TECHNICAL BULLETIN

Technical Bulletin Number	20190122
Subject	Vibration Isolating Spring Kit Modification (Drive Units)
Make & Model	DP4 SUPER (Product Code F01620 & FT201620-UNIT)
Serial Number Range	10000 to 89000 & A01-10000 to D07-99999

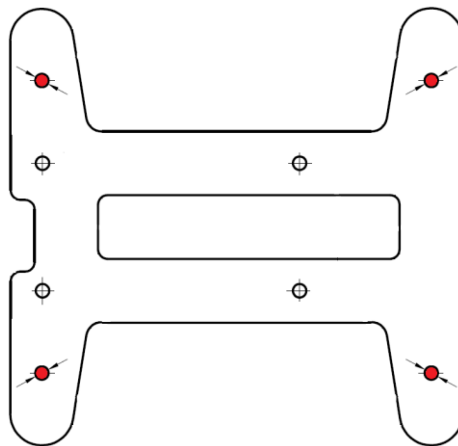
Flextool vibration isolating spring kits (Product Code: F07160 & NPS07160-UNIT) that suit Flextool DP4 SUPER Drive Units are no longer available and have been replaced with rubber mount kit (Product Code: NPS01579-UNIT)

The new rubber mount kits (Product Code: NPS01579-UNIT) require a small modification to be made to the existing bolt holes used for the spring kits in both the engine mounting plate (pictured below) and the corresponding bolt holes in drive unit frame straps.

These existing holes that currently have a 5/16 thread tapped into them need to be drilled out to 10.5mm to allow for the larger and metric thread of the rubber mounts to pass through. Once the mounts are in place they can be secured using the washers and lock nuts supplied in the kit.

The below sketch illustrates the four bolt holes that require drilling out in the engine mounting plate (Indicated in red).
